489 Congress St.

**CITY OF PORTLAND, MAINE
DEVELOPMENT REVIEW APPLICATION
PLANNING DEPARTMENT PROCESSING FORM
Planning Copy**

Maine Historical Society Research Libr

**Maine Historical Society Research Library – Site Plan Review, Submitted May 30, 2007
City Review Comments dated July 19, 2007 and July 25, 2007**

MAINE HISTORICAL SOCIETY RESEARCH LIBRARY
 1/8" = 1'-0"

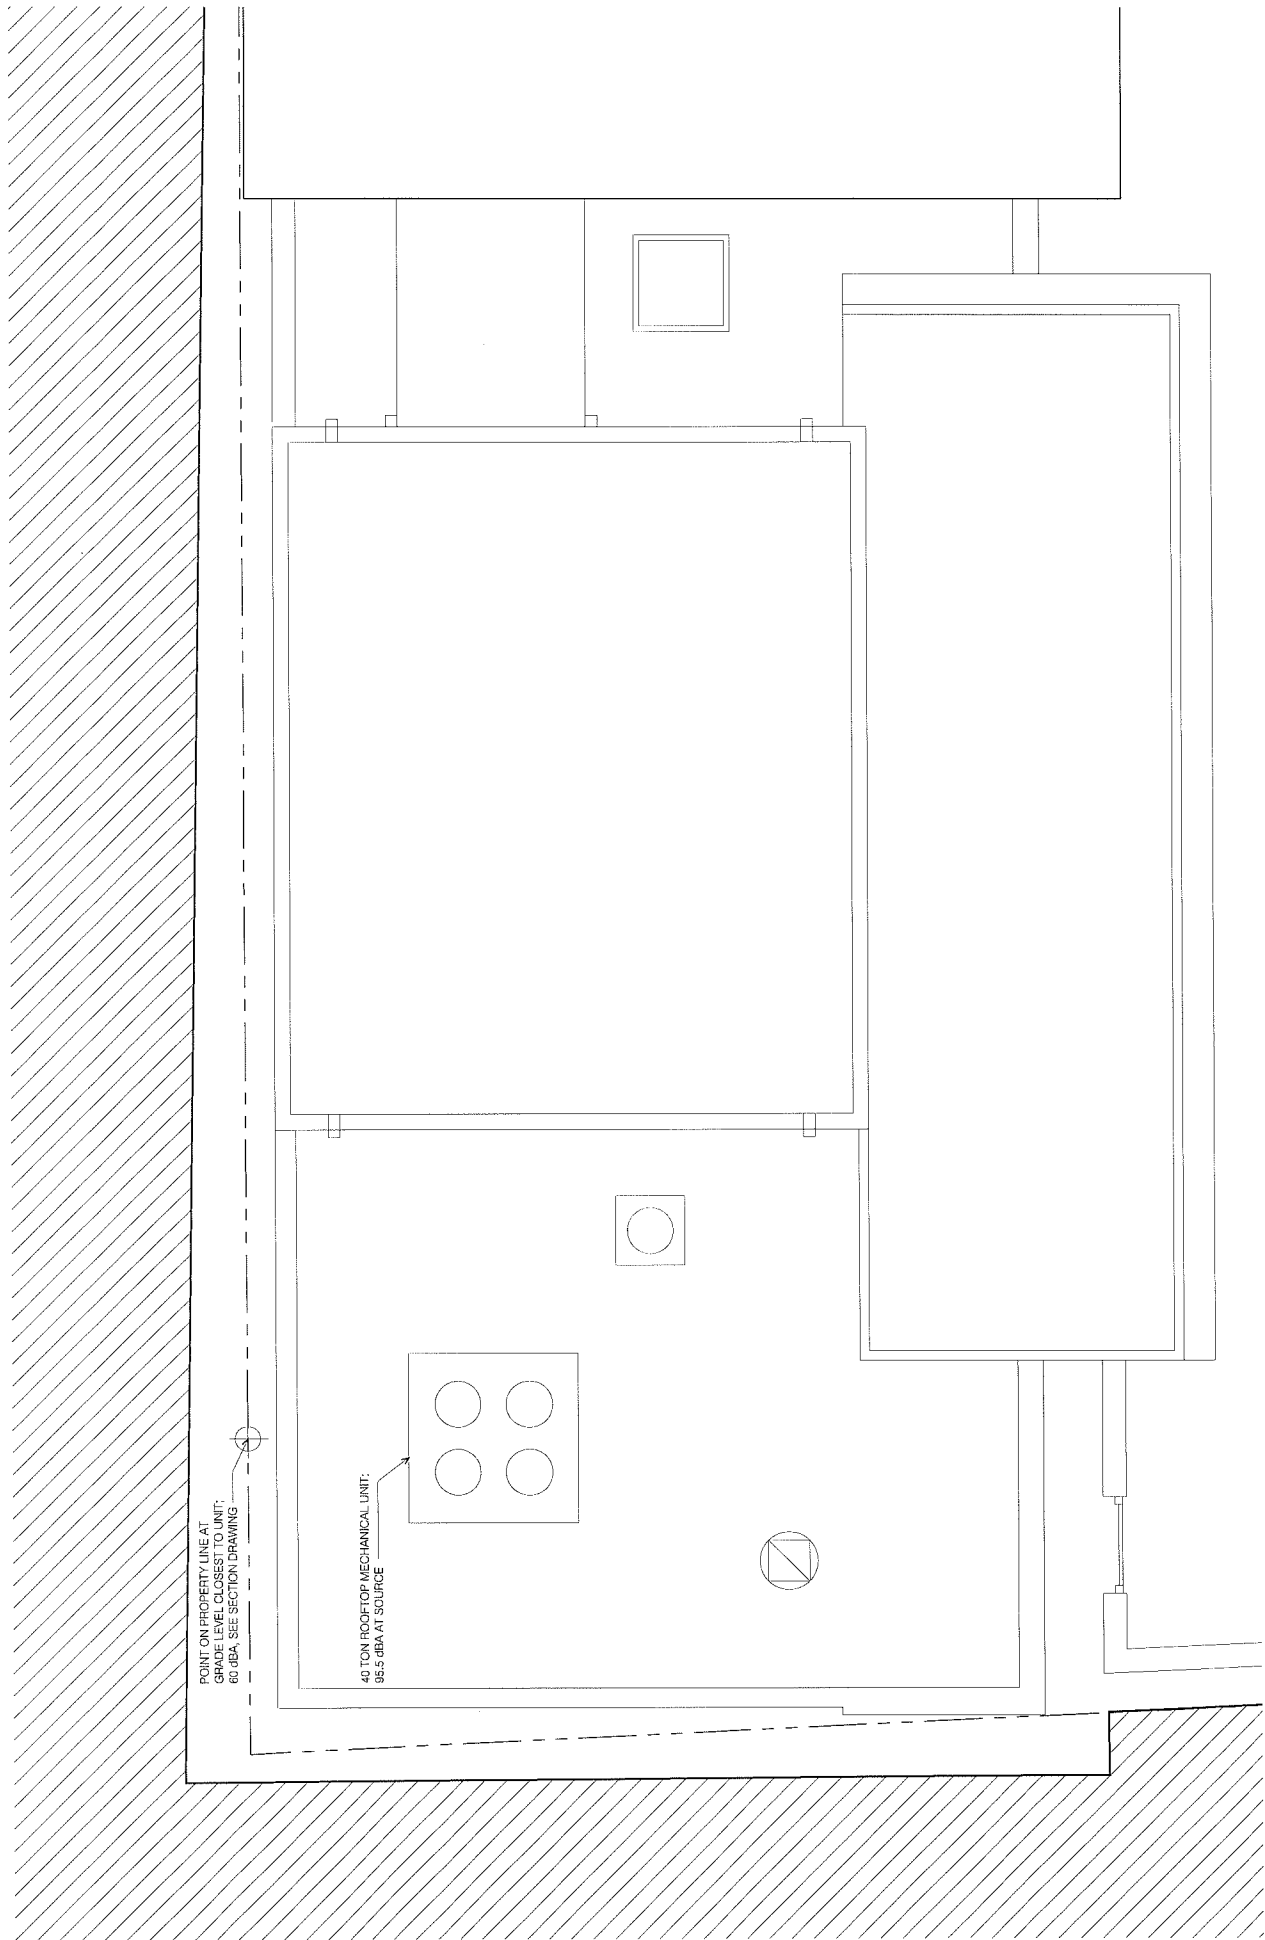
Remarks: Shukria,
Attached are files pertaining to the City of Portland's conditional site plan approval. A request was made for proof that the "HVAC system and any rooftop mechanicals related to this addition shall meet the B-3 noise regulation."

We have provided a copy of electronic correspondence between the Architect and our consulting Acoustical Engineer with regards to this issue. At a grade-level location closest to the mechanical unit along the property line, the noise level of the loudest rooftop mechanical unit is 60dBA. There is a plan and section documenting where this calculation was made. As shown, this location is non-occupied space (approximately 3'-9" in width) between the proposed building and the existing building.

POINT ON PROPERTY LINE AT
GRADE LEVEL CLOSEST TO UNIT;
60 cBA, SEE SECTION DRAWING

SECTION AT GARDEN RETAINING WALL
N.T.S.

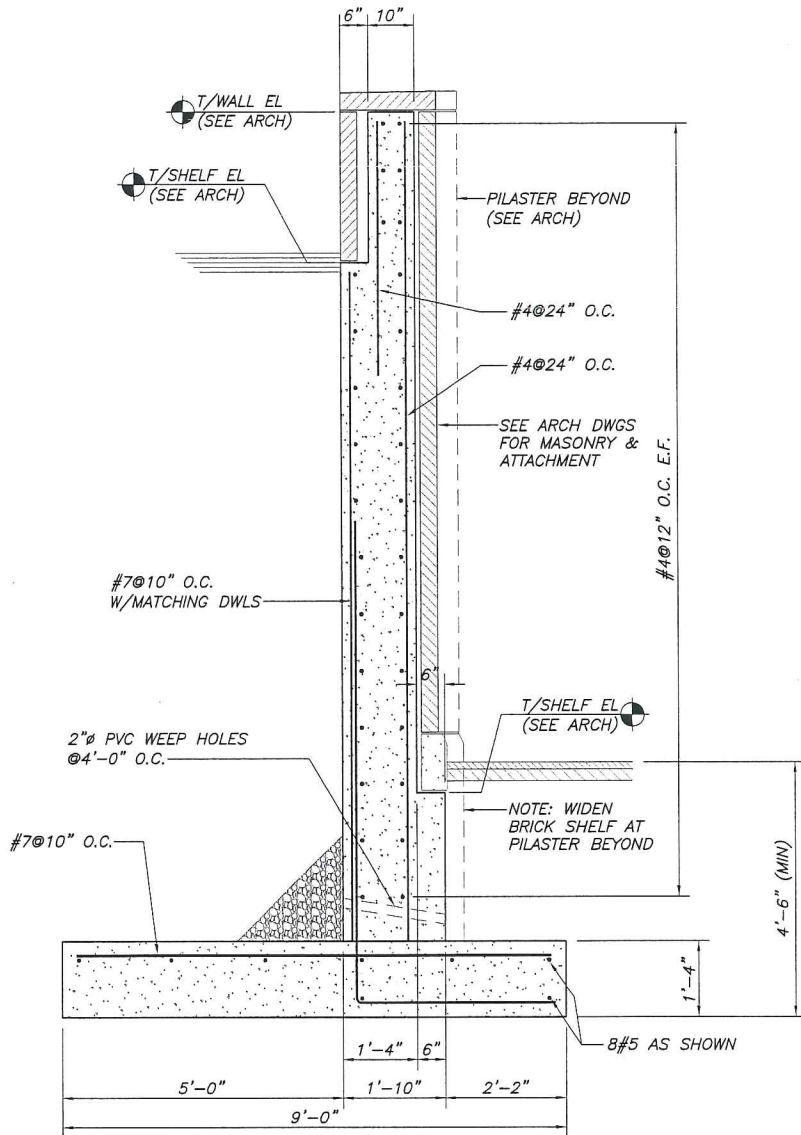
5. *Add a retaining wall typical to the civic details on S1 and S2.*

The retaining wall details are shown on the Structural Plans, Sheet S2.4

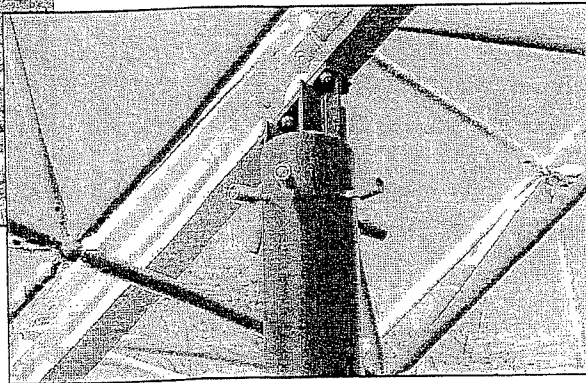
2. on the lighting plan, there is a L2 lighting being proposed at the corner of the parcel, it to be pointed to the abutting building or onto the landscaping?

All of the L2 fixtures are to be downlights mounted on 24-inch tall poles to direct lighting on the garden pathways and the handicap ramp at the front of the building. Non are to be directed at abutting buildings. Thanks.
